Access Compliance Report

Public Rights-of-Way

(Curb Ramps)

Intersection ID: 10041631	Main Street: WHITEHALL_PARK_DR	Cross Street: N/A	Location: SE
ADA ID: 5C7148EFA1BF	Ramp Type: PerpDiag	Initial Pass/Fail: Fail	Overall Compliance: No
Severity Score: 33.75			
Codes/Mitigation Info/Possible Solution		Field Measurements/Component Compliance

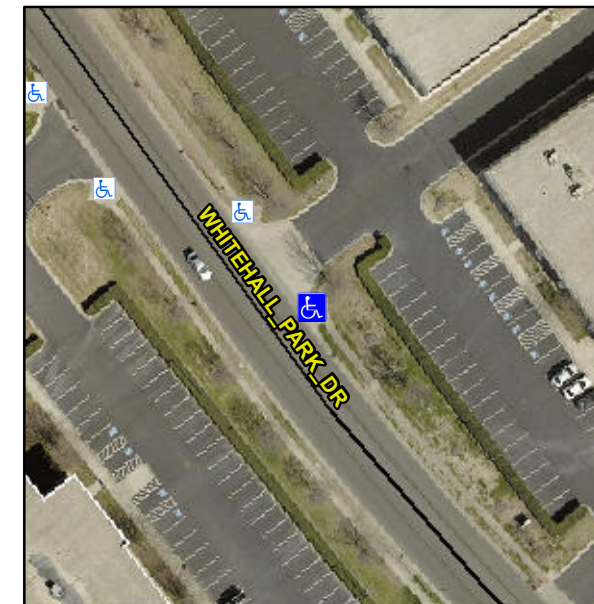
R304.5.1, R304.5.3

Compliance	Description	Data	Compliance	Description	Data
N/A	Ramp Length (in)	48.0	Yes	Ramp Slope (%)	6.0
No	Ramp Width (in)	40.0	No	Ramp XSlope (%)	7.7
N/A	Flare Type LT	N/A	N/A	Flare Type RT	N/A
N/A	Flare Slope LT (%)	N/A	N/A	Flare Slope RT (%)	N/A
N/A	Flare Traversable LT?	N/A	N/A	Flare Traversable RT?	N/A
N/A	Landing Length (in)	N/A	N/A	DWS Provided?	N/A
N/A	Landing Width (in)	N/A	N/A	DWS Contrast?	N/A
N/A	Landing Slope (%)	N/A	N/A	DWS Length (in)	N/A
N/A	Landing X Slope (%)	N/A	N/A	DWS Full Width?	N/A
N/A	Landing Curb? (Y/N)	N/A	N/A	DWS Offset (in)	N/A
N/A	Shared Landing?	N/A			
N/A	Gutter Ponding?	N/A	N/A	Gutter Slope (%)	N/A
N/A	Gutter Lip Ht (in)	N/A	N/A	Gutter X Slope (%)	N/A
N/A	Painted X Walk1?	No	N/A	Painted X Walk2?	No
	X Walk 1 Direction	To NW		X Walk 2 Direction	To SW
N/A	X Walk 1 Width (in)	N/A	N/A	X Walk 2 Width (in)	N/A
	X Walk 1 Slope (%)	0.5		X Walk 2 Slope (%)	10.9
	X Walk 1 X Slope (%)	14.4		X Walk 2 X Slope (%)	2.6

Remove & Replace Curb Ramp With Two New Directional Ramps or Equivalent.
